ORDINANCE NO. 5350

AN ORDINANCE PROCLAIMING THE APPROVAL OF A TENTATIVE SUBDIVISION PLAT APPLICATION (FILE M1-10-97), A CONCURRENT SITE PLAN REVIEW APPLICATION (FILE SP-98-97), AND A DEVELOPMENT AGREEMENT (DA-01-98) FOR PROPERTY LOCATED SOUTH OF GRAND PRAIRIE ROAD SE AND WEST OF INTERSTATE 5 (TAX LOT 1400, LINN COUNTY ASSESSOR'S MAP 11-3W-16); ADOPTING FINDINGS; AND DECLARING AN EMERGENCY.

EXHIBIT C
FINDINGS OF FACT FOR TENTATIVE SUBDIVISION APPROVAL
FILE M1-10-97

EDGEWOOD ESTATES SECOND ADDITION TENTATIVE PLAN A PART OF TAX LOT 1400 SECTION 16, TOWNSHIP 11 SOUTH, RANGE 3 WEST, WILLAMETTE MERIDIAN LINN COUNTY, OREGON

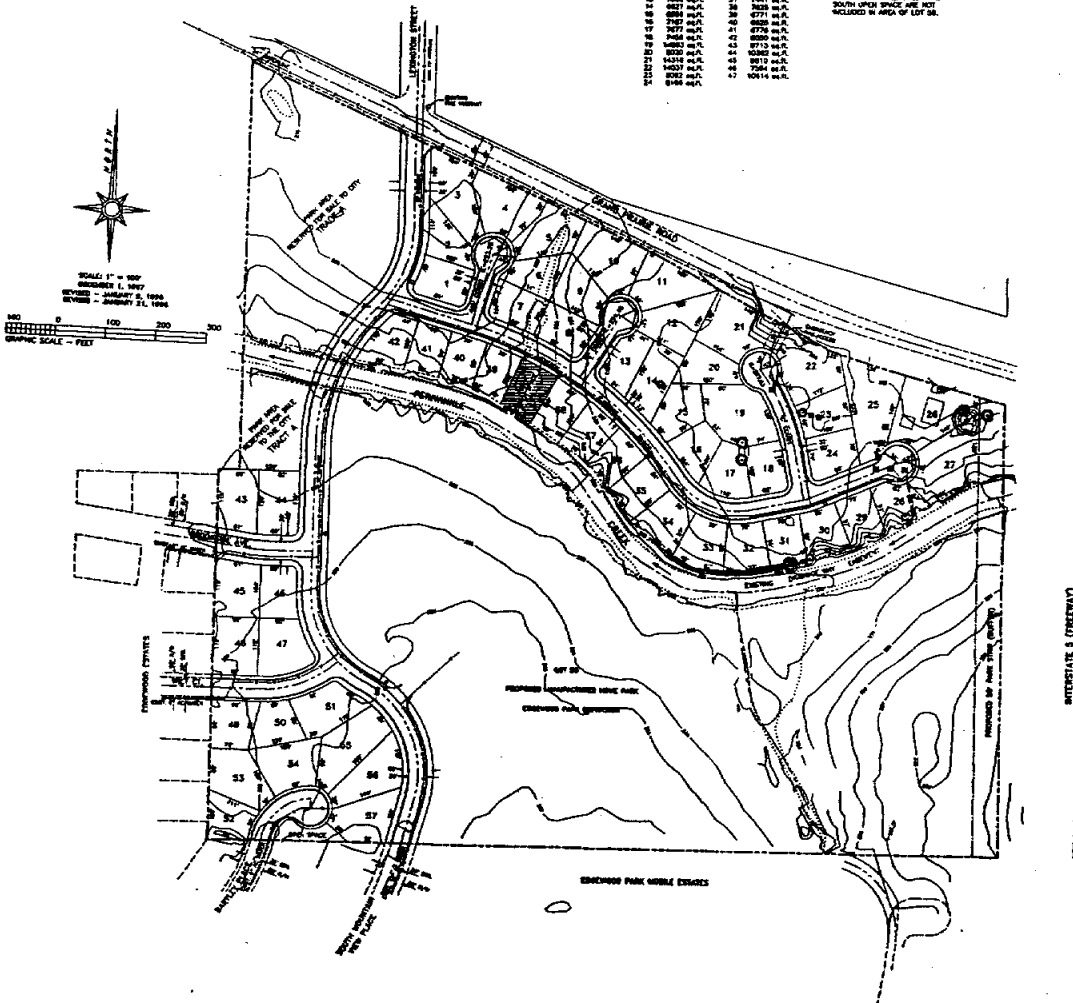
- 4.19 The existing 30-inch pipe along the west boundary of the subject property is located within a 10-foot wide public easement (Linn County deed records MF-115-795). The tentative plat does not show the easement. It appears the easement is located along the west edge of proposed Lots 43, 45, and 48. The easement must be shown on the plat.

- 4.20 The storm drain plan submitted by the applicant does not show a specific type of drainage structure where the new Mountain View Drive will cross Periwinkle Creek. City staff observes that there are far fewer problems with drainage structures that have one clear span than there are with multiple span structures. The major problems with multiple span structures include head loss at the inlet, and plugging with brush, trees, and debris. A single span structure will be required (either a culvert or a bridge) to minimize the possibility of flooding that might occur if a multiple span structure was constructed.

The tentative plat submitted by the applicant does not show the location of the 100-year flood contour line followed by the date the flood elevation was established. The elevation has been determined in the drainage calculations submitted by the applicant. The calculations have been certified by a registered

3.1 Center line curve radii for streets within the proposed subdivision shall be a minimum of 200 feet. The tentative plat appears to show a 150-foot radius curve on Heyerly Place. The final plat shall be revised to show a 200-foot minimum radius curve.

- 4.17 The existing 30-inch pipe along the west boundary of the subject property is located within a 10-foot wide public easement (Linn County deed records MF-115-795). The tentative plat does not show the easement. It appears the easement is located along the west edge of proposed Lots 43, 45, and 48. The easement must be shown on the plat.

- 4.18 The storm drain plan submitted by the applicant does not show a specific type of drainage structure where the new Mountain View Drive will cross Periwinkle Creek. This crossing must be constructed as a single span structure (either a culvert or a bridge).

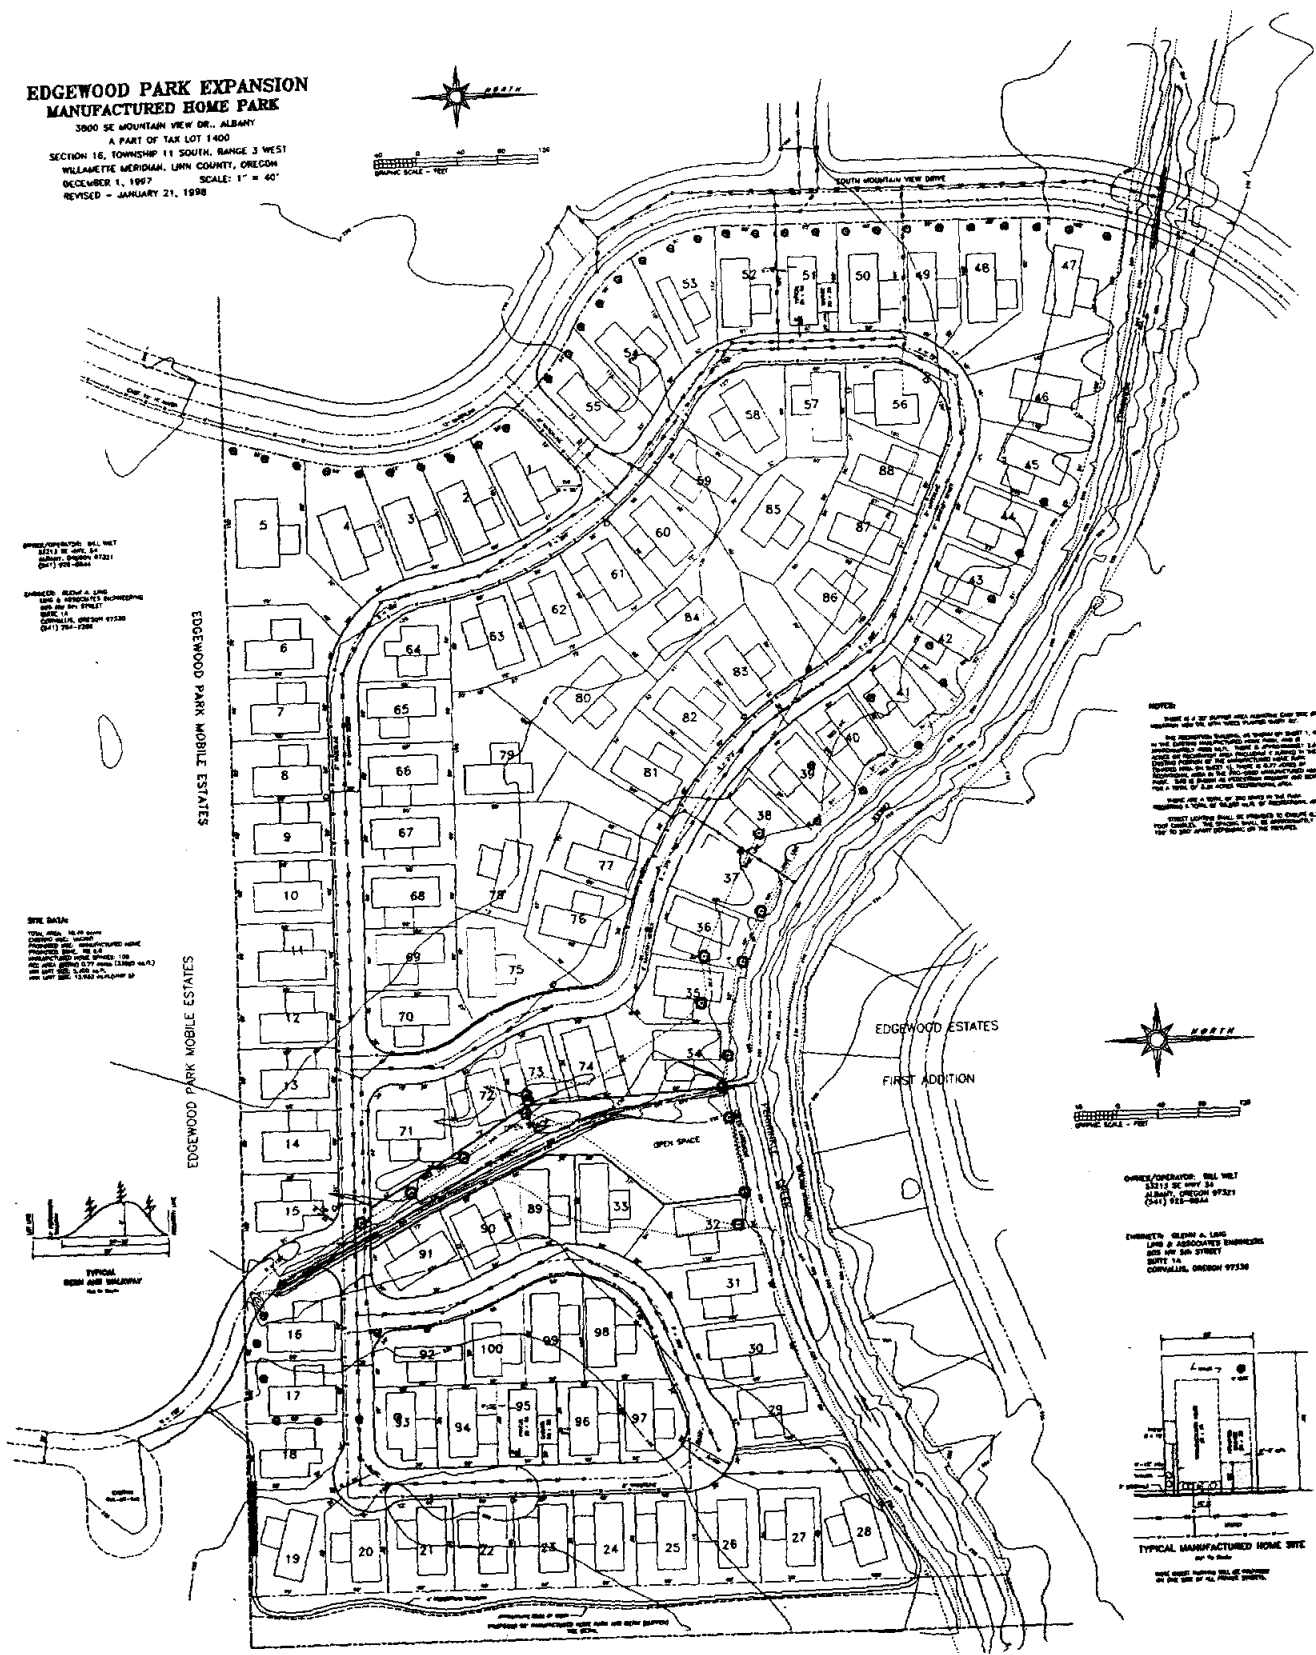
The plans do not show a system of walkways that would meet this requirement. Sheet 3 of 3 of the plans shows a plot plan of a typical manufactured home space, with a 3-foot wide sidewalk behind the curb of the street. It is implied from this drawing that each home will be connected to the other homes by constructing sidewalks along the frontage of each space. It is feasible to do this, but it is not clear from the plan that is what is intended. In addition, the sidewalks must be 4-foot wide. A walkway that connects the streets to the proposed common area within the freeway noise buffer area and then to the existing manufactured home park to the south where most of the recreation facilities for the park expansion will be located is shown. A revised plan that shows the entire sidewalk system, with 4-foot wide sidewalks, must be submitted. This will be a condition of approval of the manufactured home park.

- 3.3 A 50-foot wide additional noise setback has been provided along the east boundary of the proposed park adjacent to Interstate 5, in conformance with ADC 3.320. Sheet 3 of 3 of the plans submitted by the applicant shows a 6-foot high berm, approximately 24-36 feet in width to be constructed within the 50-foot setback, with a 4-foot wide path along it.

The plans that were submitted for the manufactured home park do not show a system of walkways that would meet this requirement. Sheet 3 of 3 of the plans shows a plot plan of a typical manufactured home space, with a 3-foot wide sidewalk behind the curb of the street. It is implied from this drawing that each home will be connected to the other homes by constructing sidewalks along the frontage of each space. It is feasible to do this, but it is not clear from the plan that's what is intended. In addition, the sidewalks must be 4-feet wide. A walkway that connects the streets to the proposed common area within the freeway noise buffer area and then to the existing manufactured home park to the south where most of the recreation facilities for the park expansion will be located is shown on the plans.

- 3.3 Provide a 10-foot wide area of buffering and screening along the east boundary of the park, within the 50-foot wide noise buffer along Interstate 5. Construct the 6-foot high, 24- to 36-foot wide berm shown on Sheet 3 of 3 of the plans. This berm meets the screening requirement for this boundary of the park. (ADC 9.250 allows "an earth berm combined with evergreen plantings or a fence which forms a sight and noise buffer a least six feet in height within two years of installation.")
